SCHEMATIC CONDUIT DIAGRAM  
 OVER LEWES & REHOBOTH CANAL  
 SAVANNAH ROAD BRIDGE

SAVANNAH ROAD BRIDGE  
 LEWIS I. DEBEL  
 SCALE: AS LISTED  
 DATE: 1/21/83  
 PASCALE LEAF LIGHTING & POWER  
 TUDOR Z ELEC  
 DRAWING NUMBER  
 OFFICE COPY

HARDESTY & HANOVER  
 CONSULTING ENGINEERS  
 W. B. Burgess  
 MAY 2, 1983

SECTION LOOKING SOUTH AT INSIDE WEST PIER

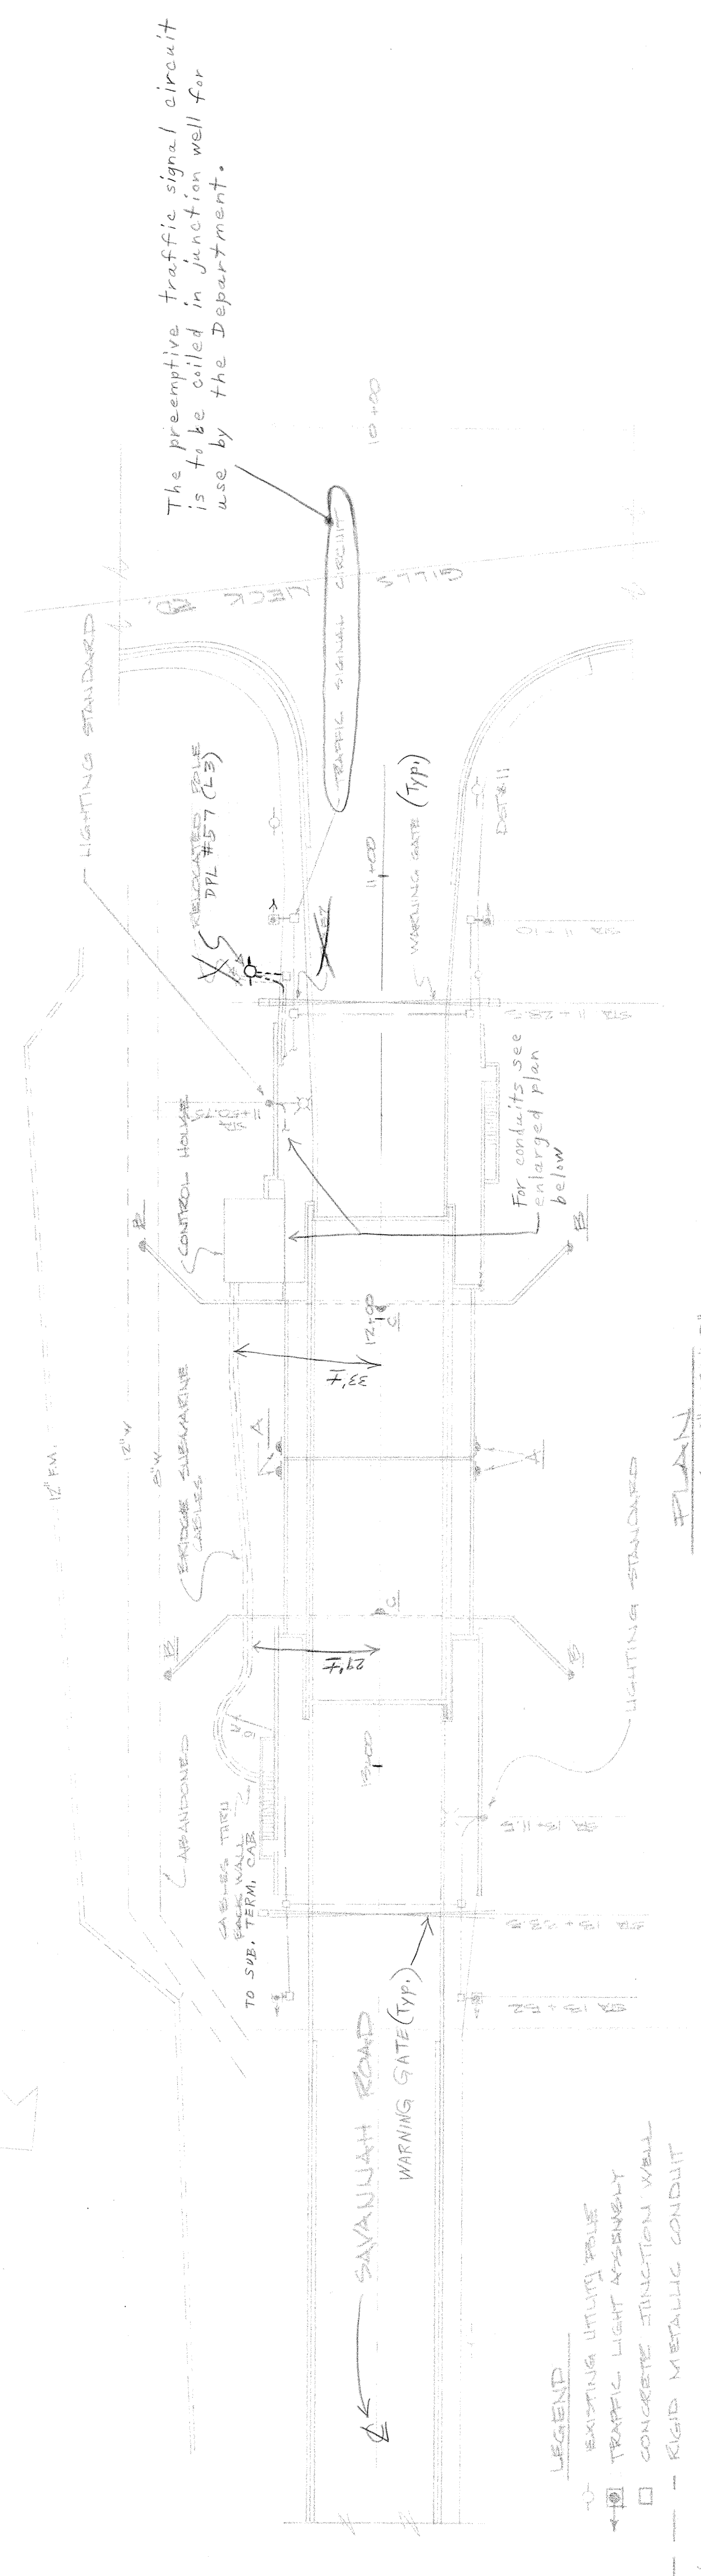
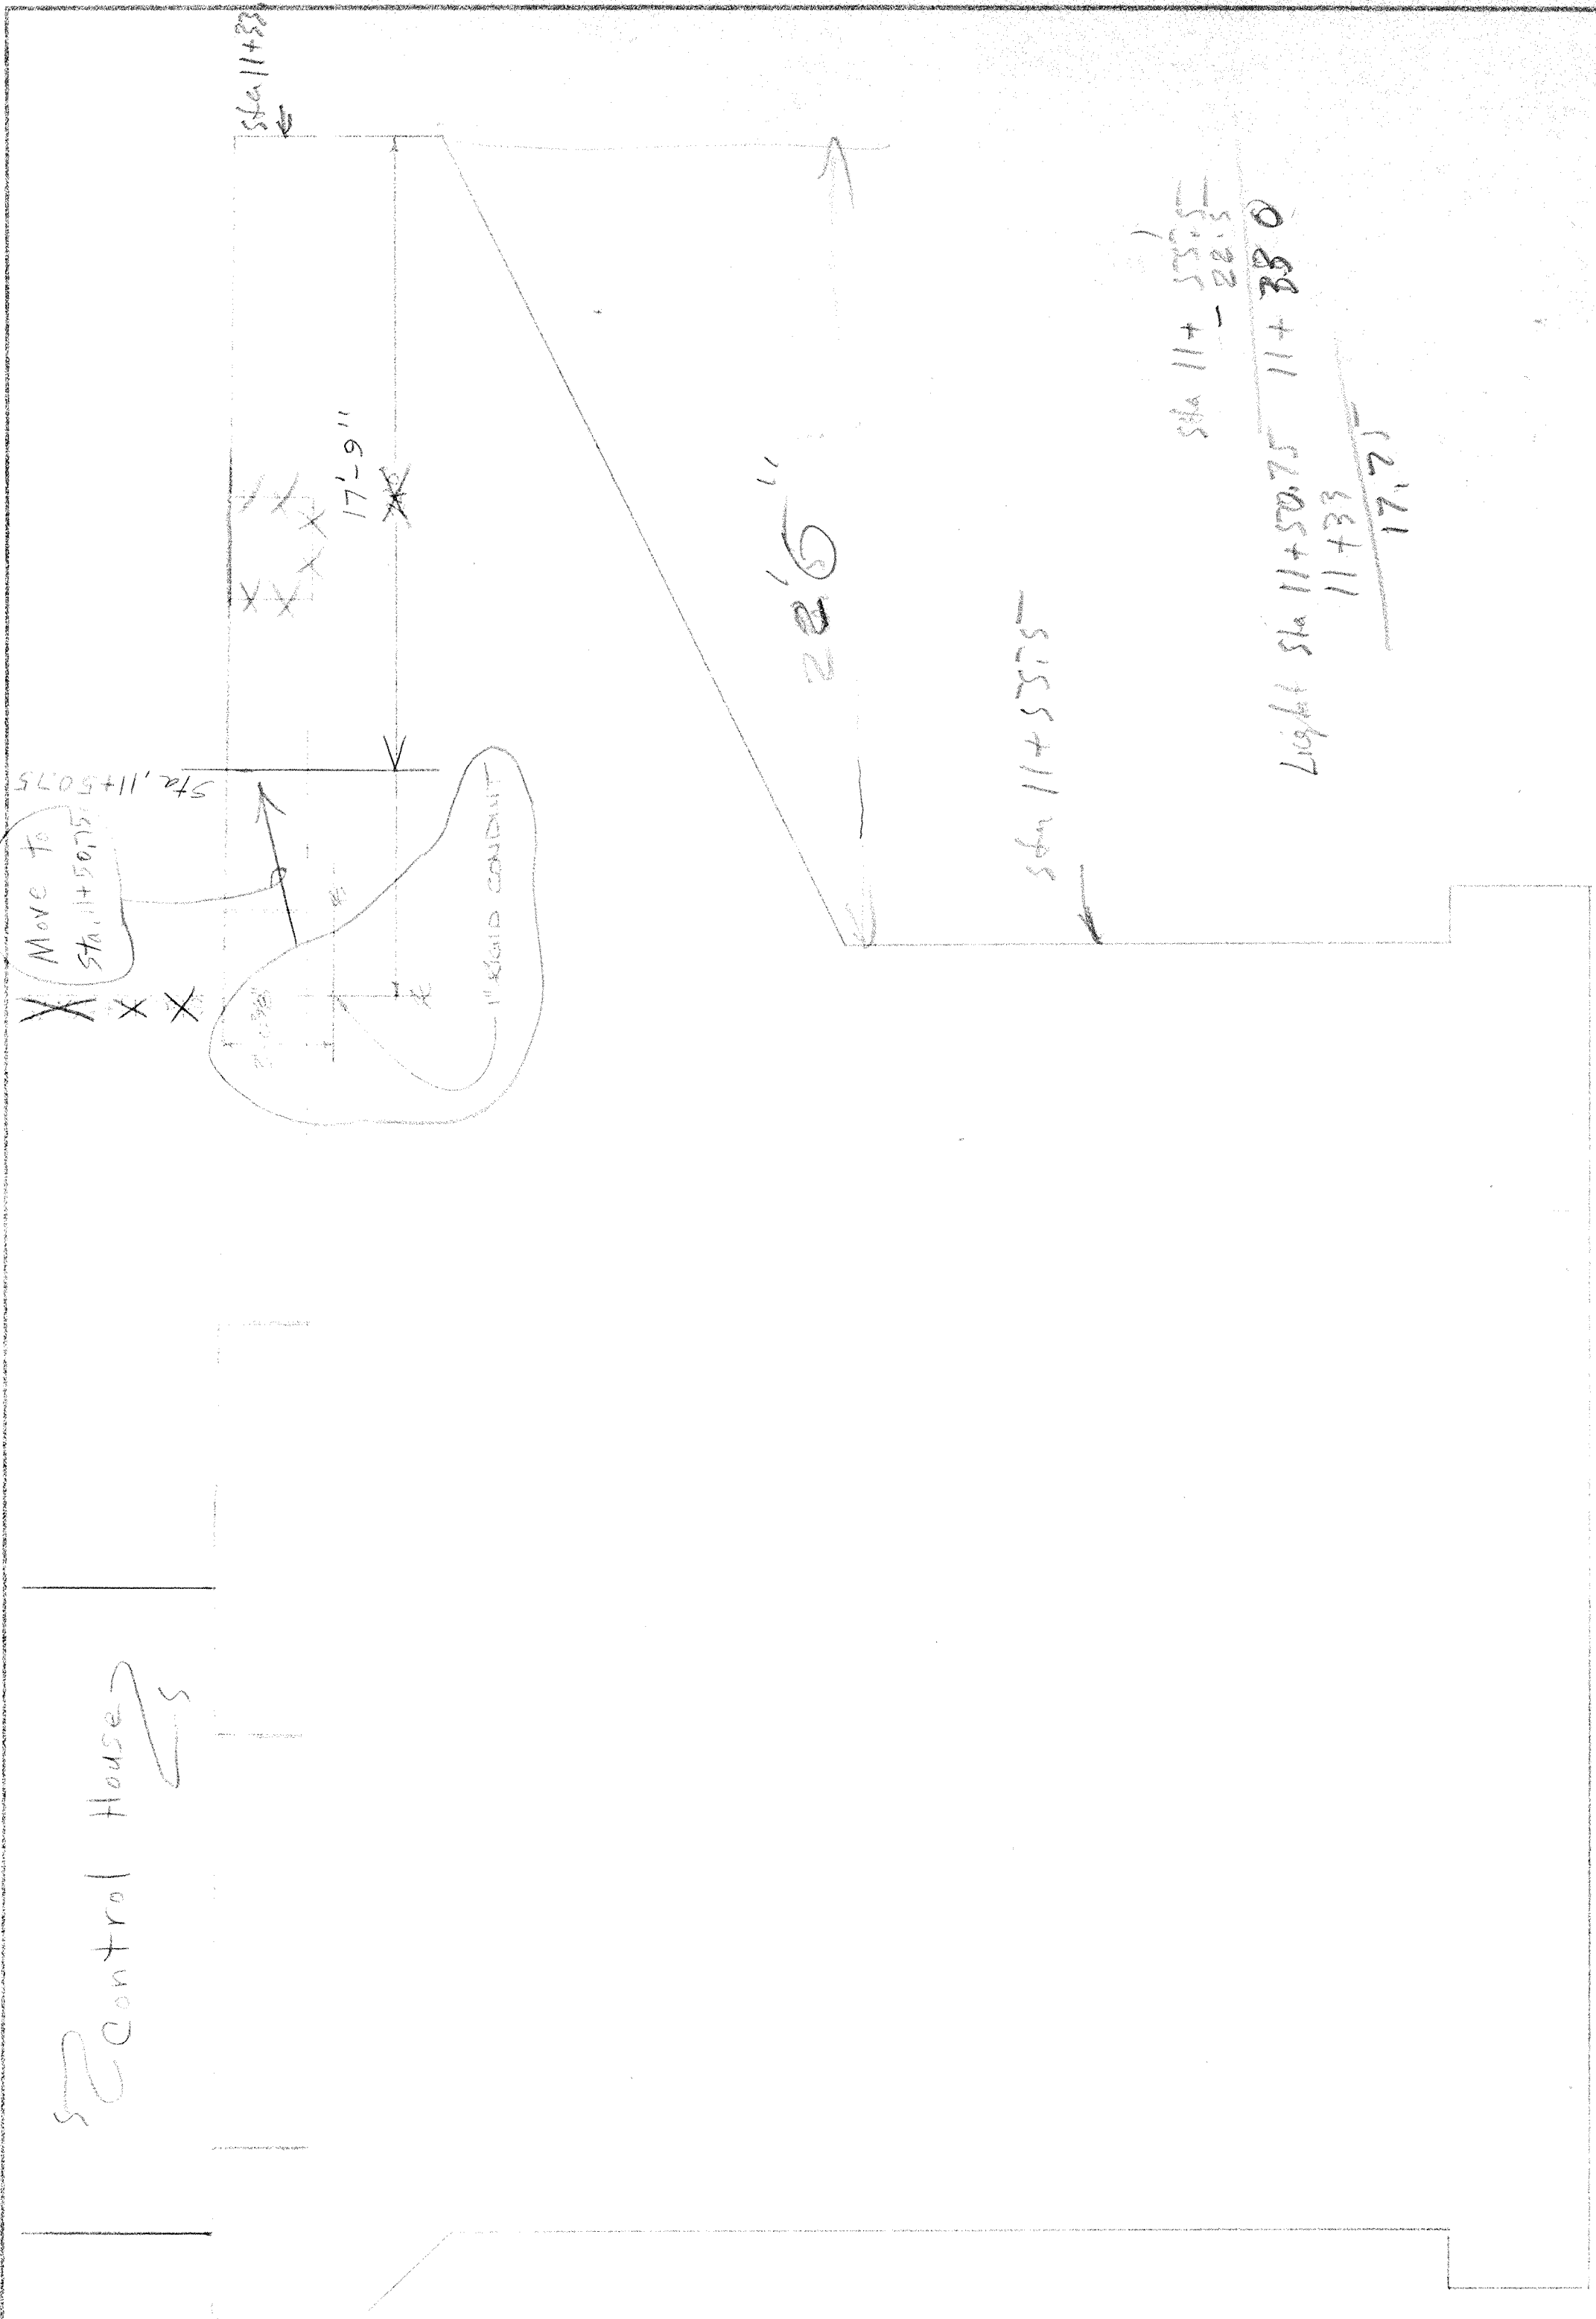
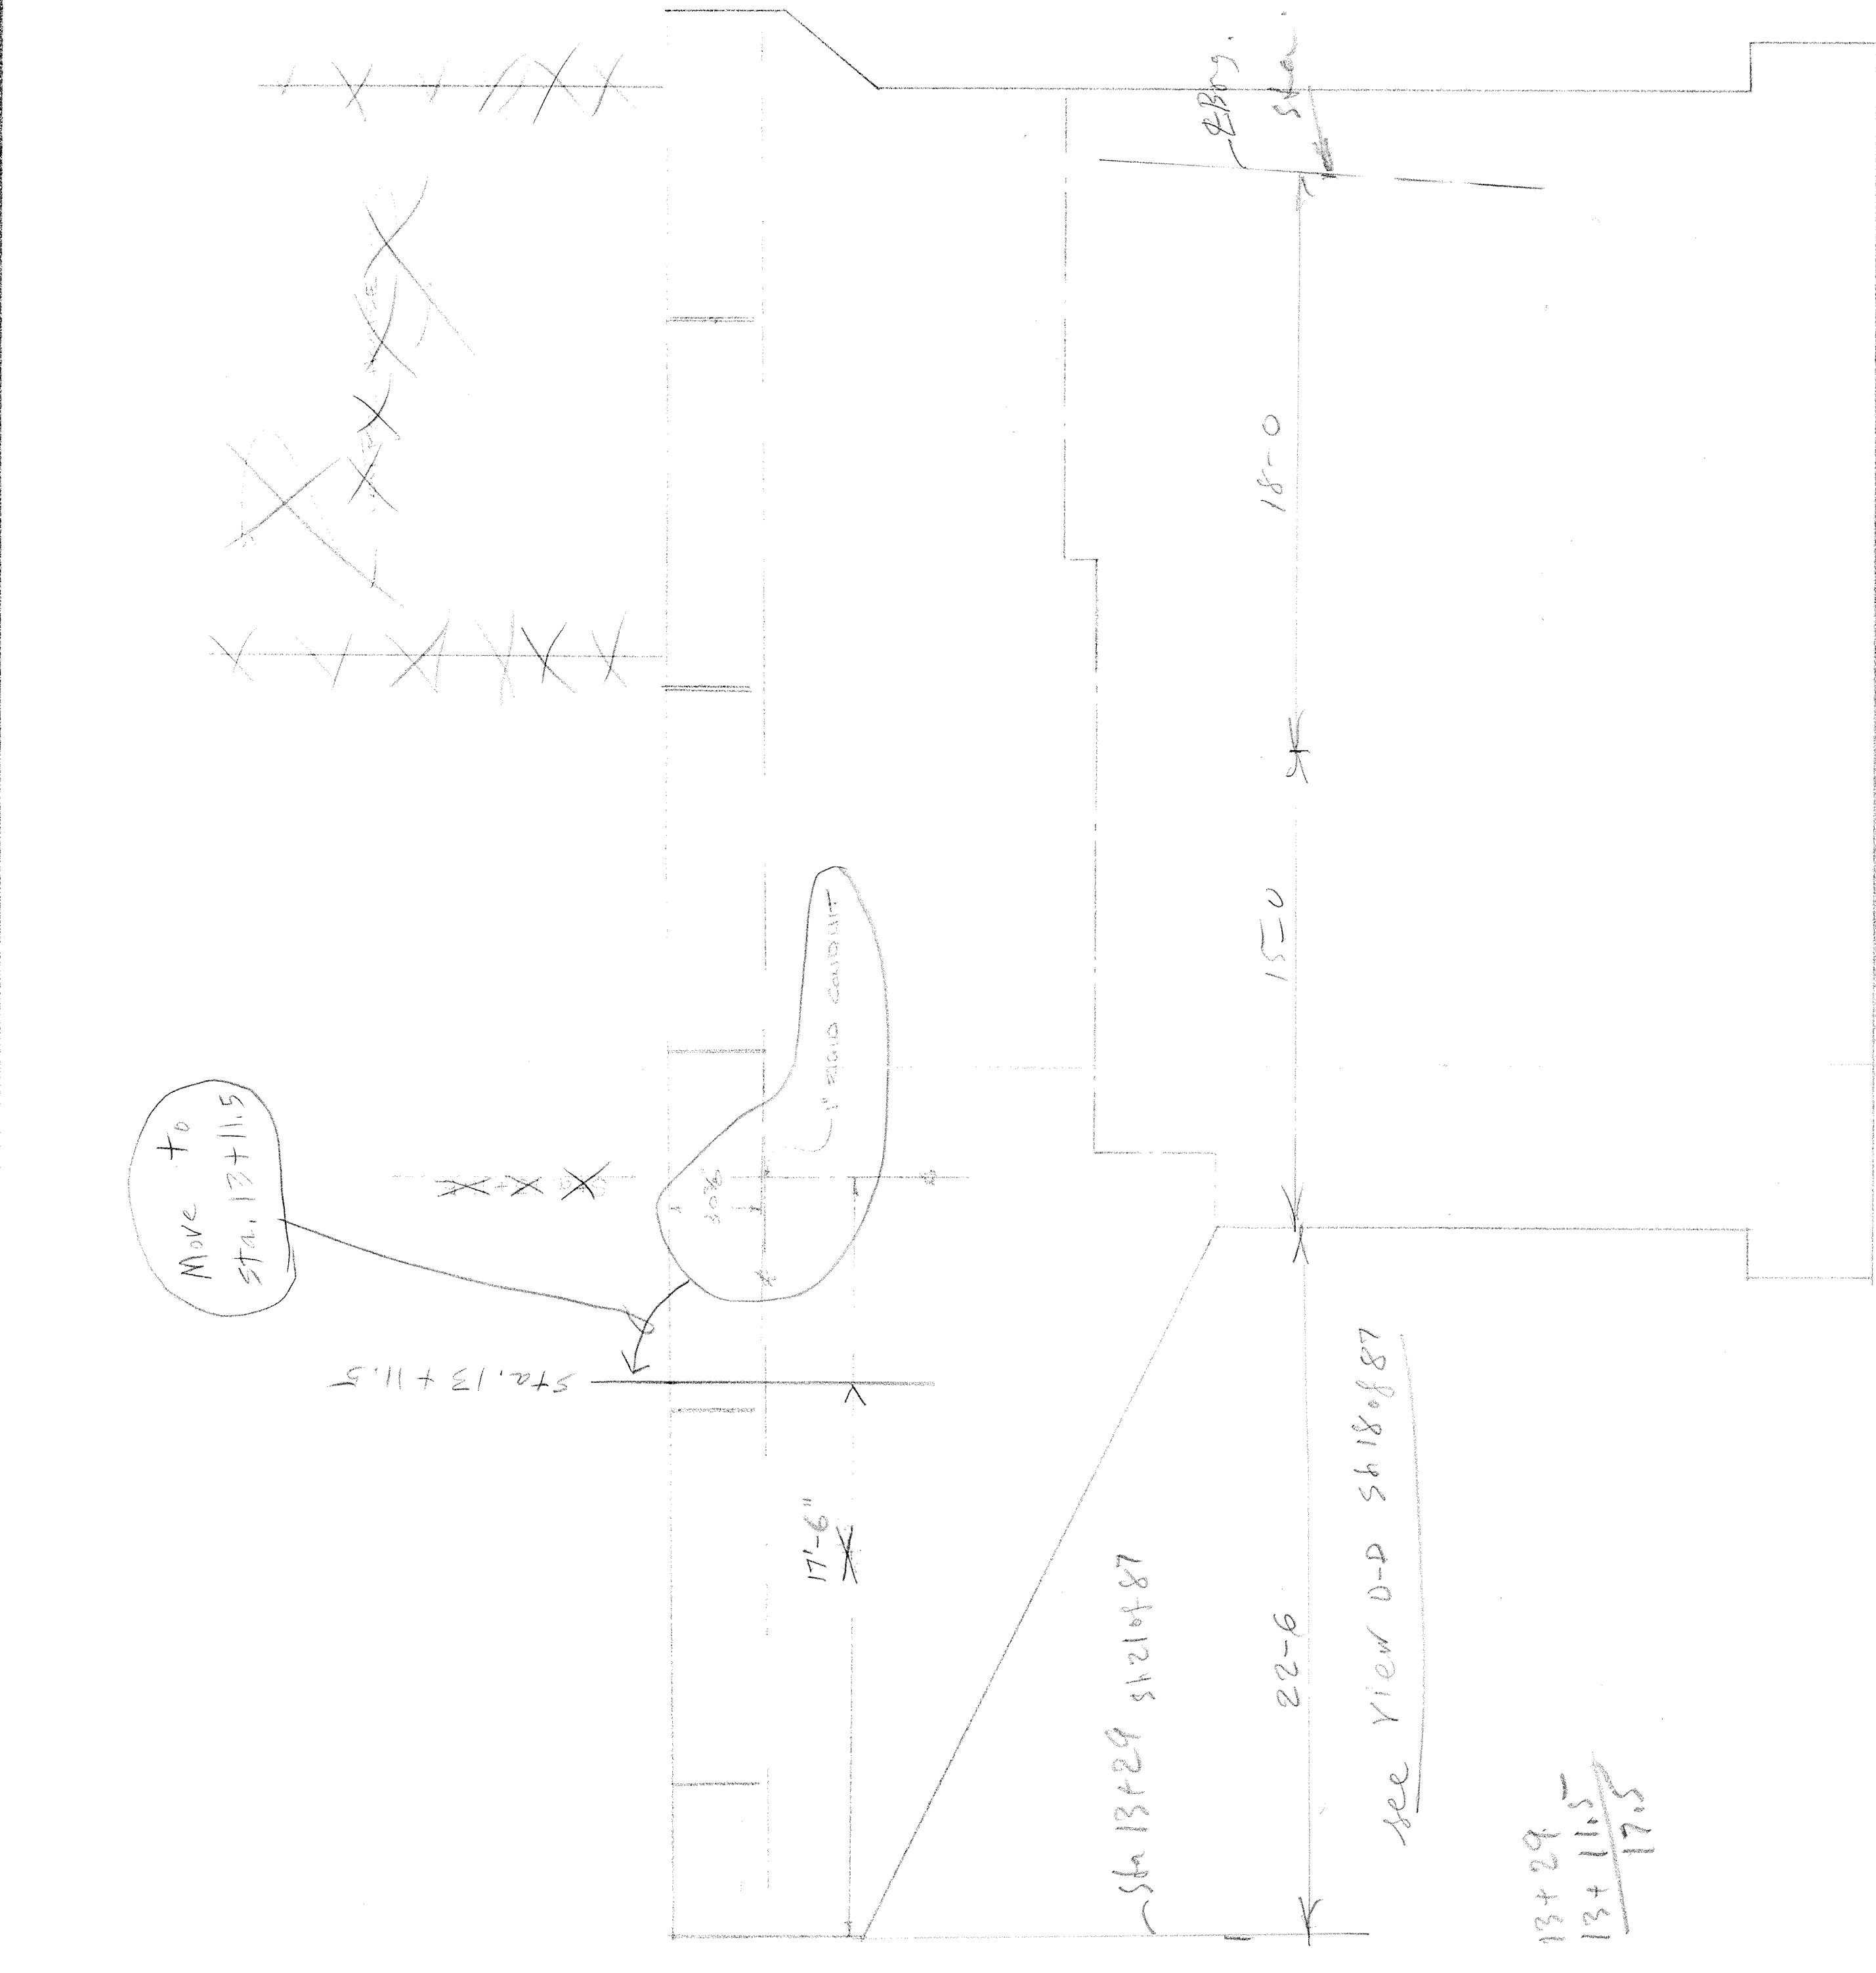
NOTE: SEE DRAWG. 61 OF STATE HIGHWAY PRINTS FOR DETAILS ON BOLT PATTERN FOR PARAFET LIGHTING STANDARD MOUNTING

see sh 24 of 87

Black notes are check notes by Anatele

SEE SHEET 61 OF CONTRACT DRAWINGS, SECTION A-A OF LIGHTING STANDARD MOUNTING

see View D-D Sh 18 of 87
